Addendum No. 1
Four Rivers Sanitation Authority
Maintenance Building Renovation
Capital Project No. 2102

This Addendum Number 1, dated July 17, 2026, for the above-referenced project, supersedes all contrary and conflicting information in the specifications and contract documents, which are hereby supplemented or revised as follows:

Ref. North Sheet No.
A402

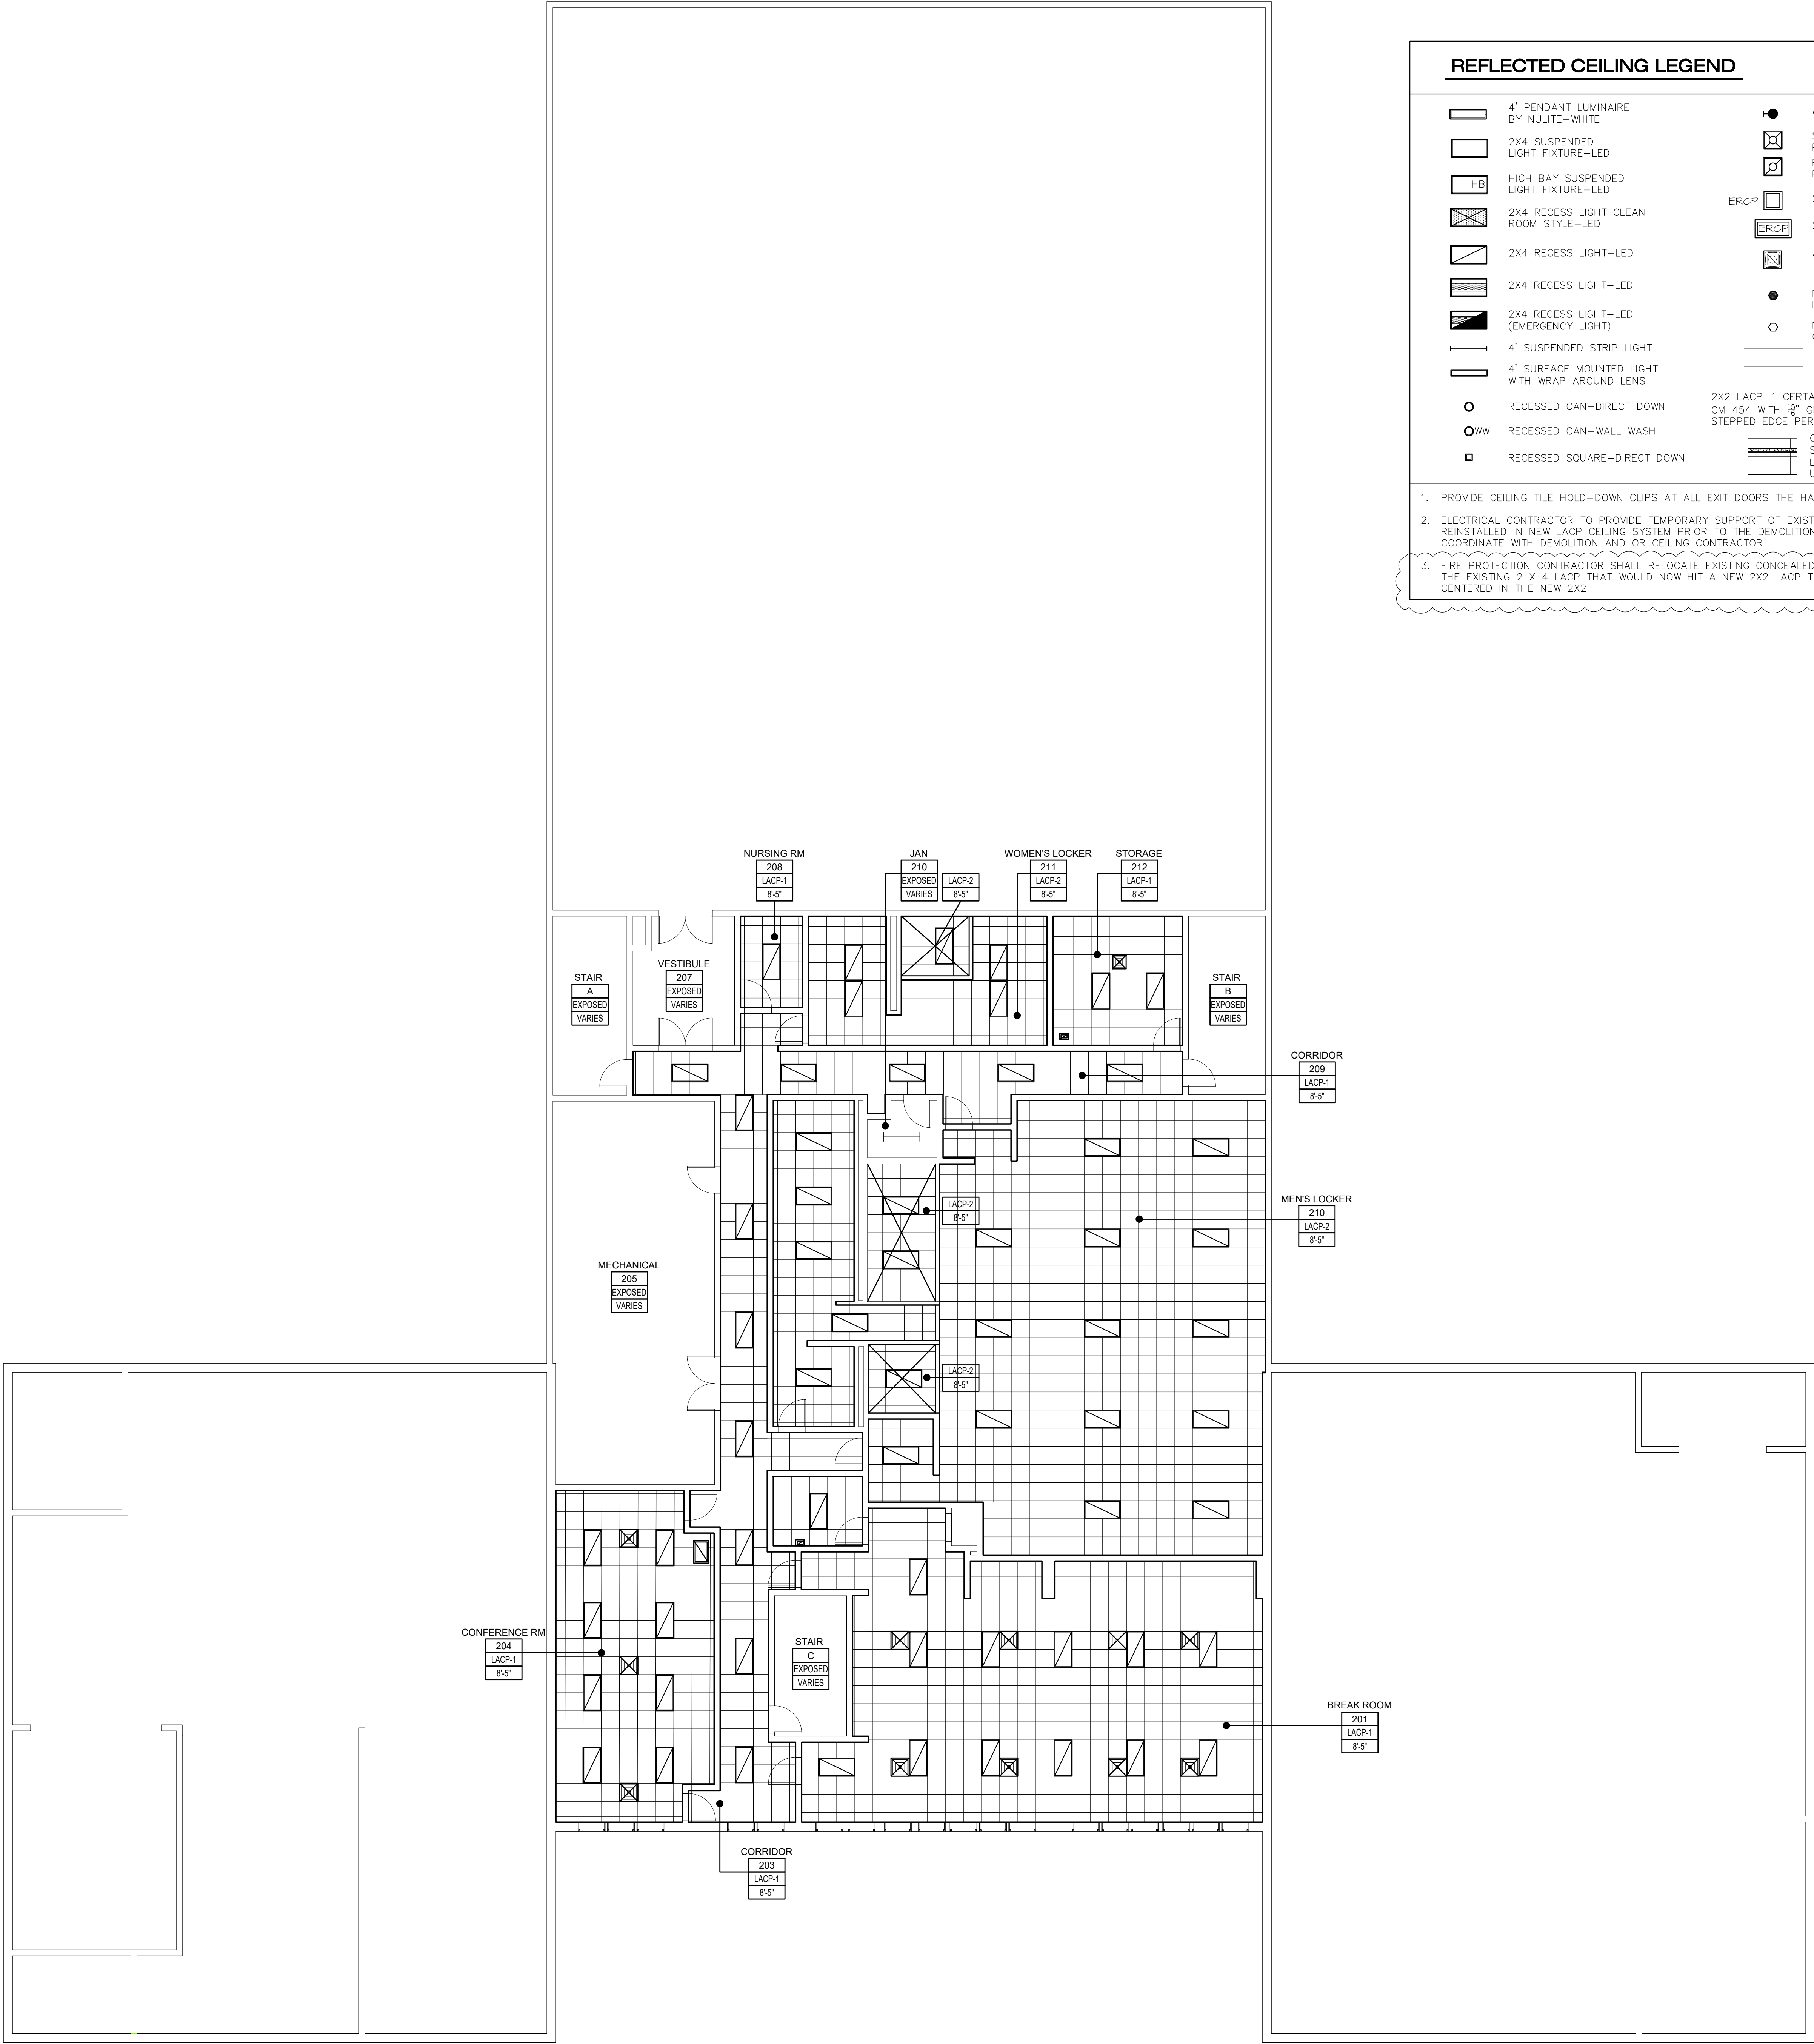
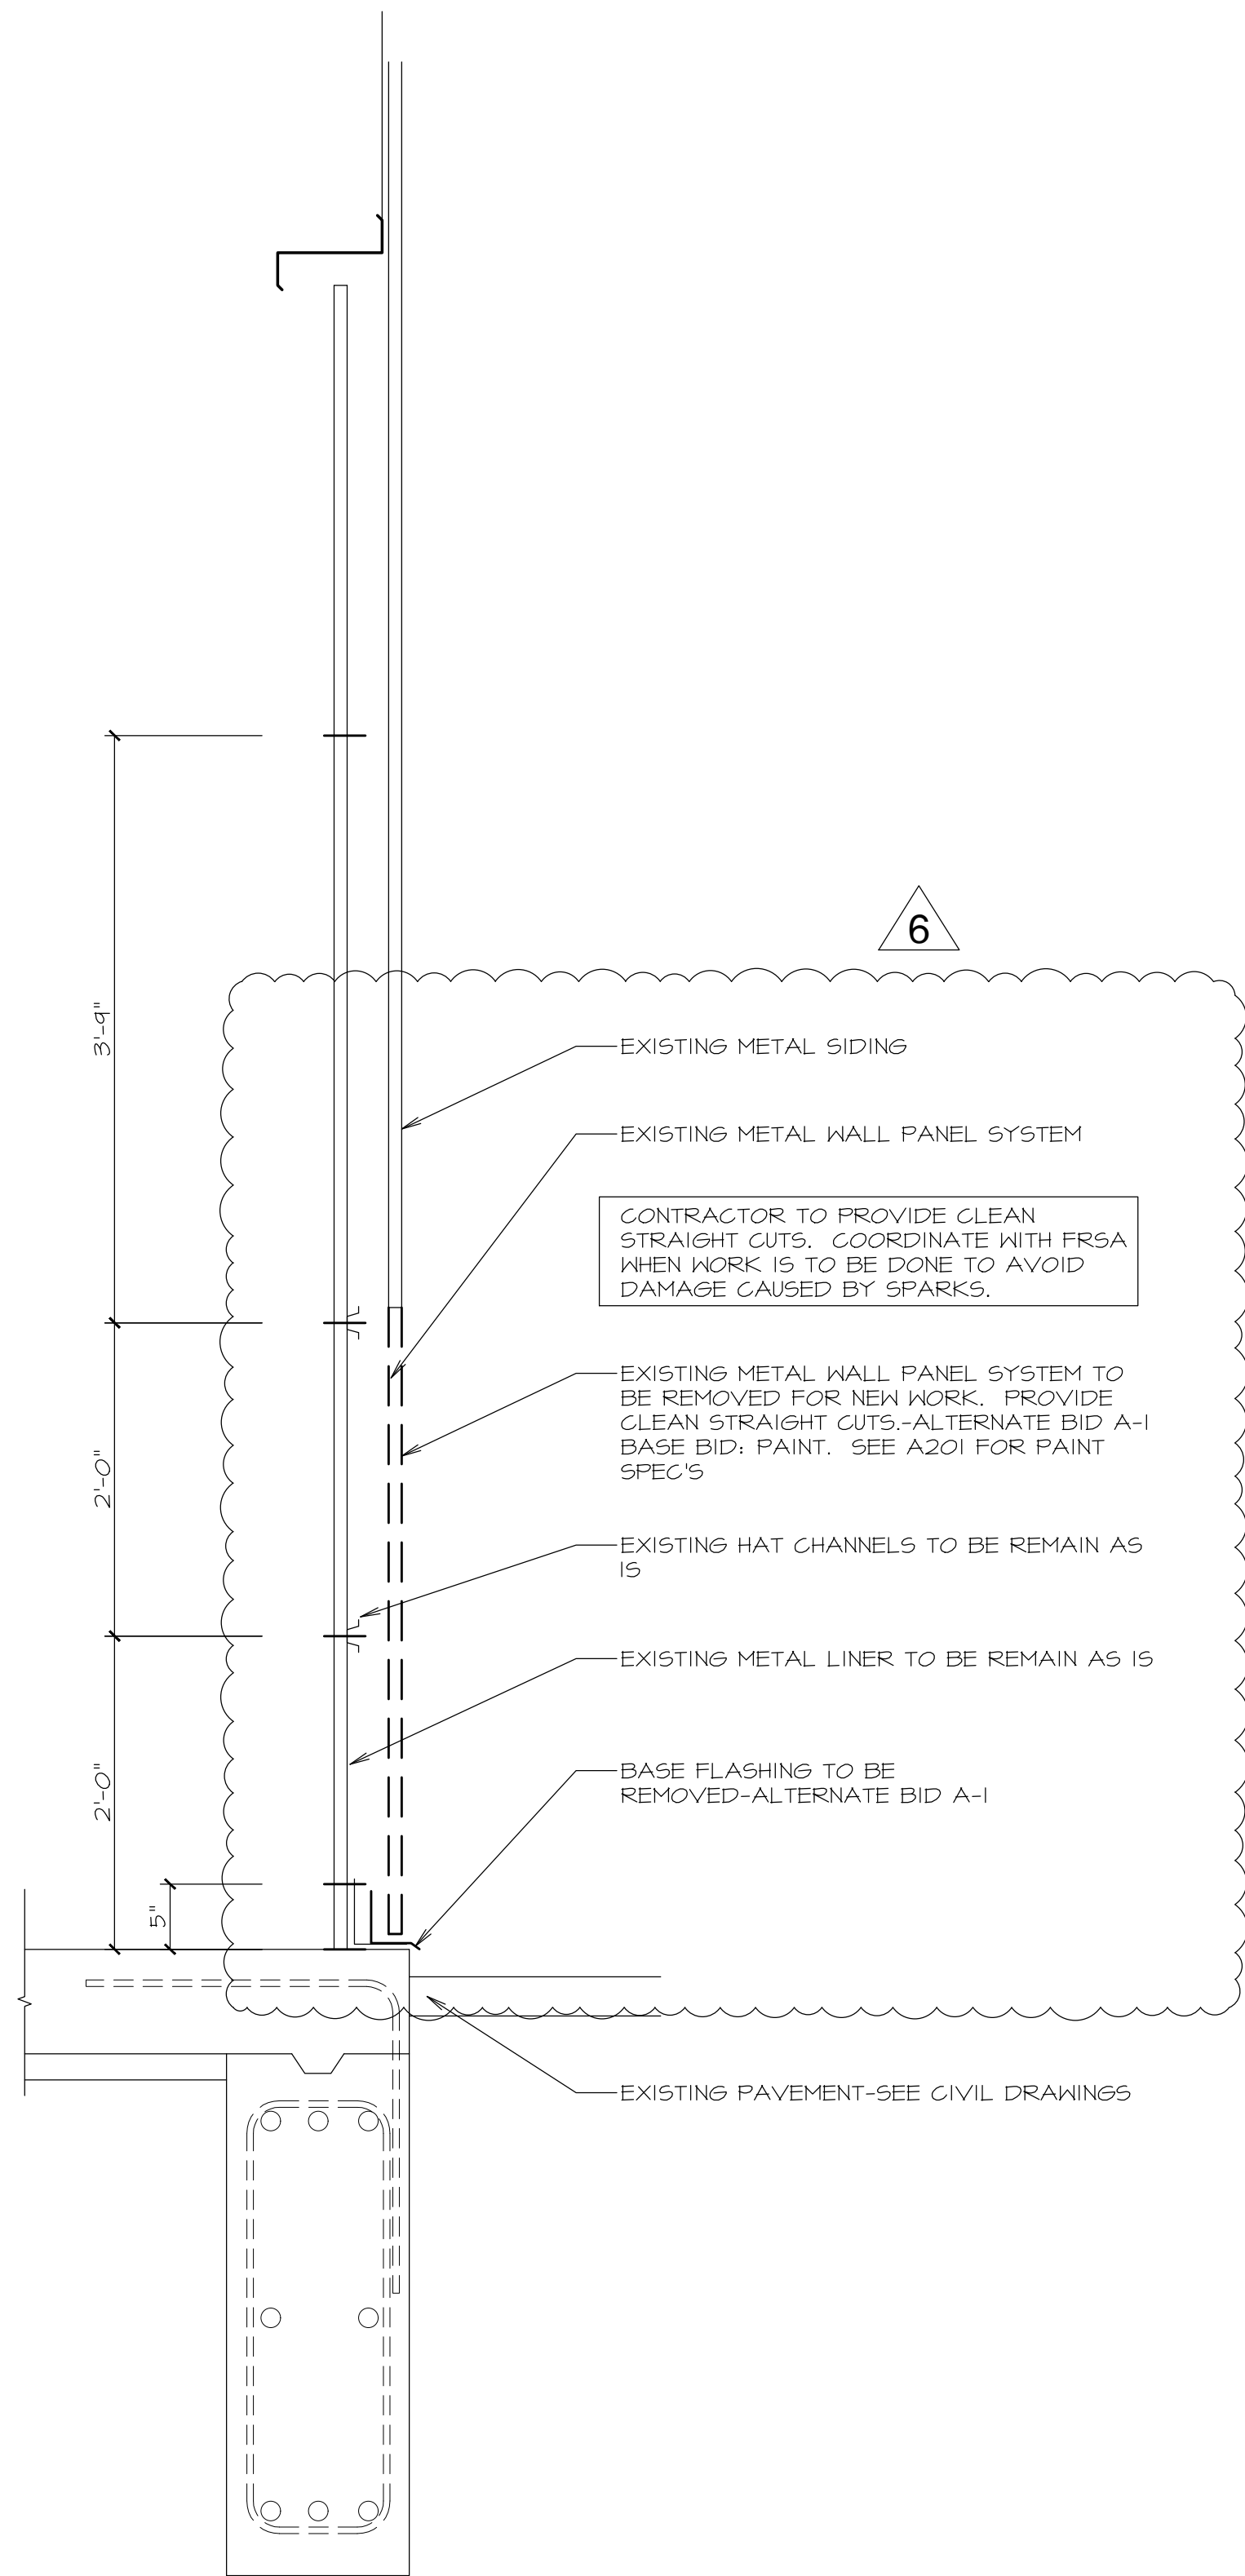
Plan Sheet A402 Reflected Ceiling Plan Second Floor: DELETE Sheet A402 in its entirety and REPLACE with the attached revised sheet which notes requirements for relocating existing concealed sprinkler heads.

3. FIRE PROTECTION CONTRACTOR SHALL RELOCATE EXISTING CONCEALED SPRINKLER HEADS THAT WERE CENTERED IN THE EXISTING 2 X 4 LACP THAT WOULD NOW HIT A NEW 2X2 LACP TEE BAR GRID SO THE EXISTING HEAD WILL BE CENTERED IN THE NEW 2X2
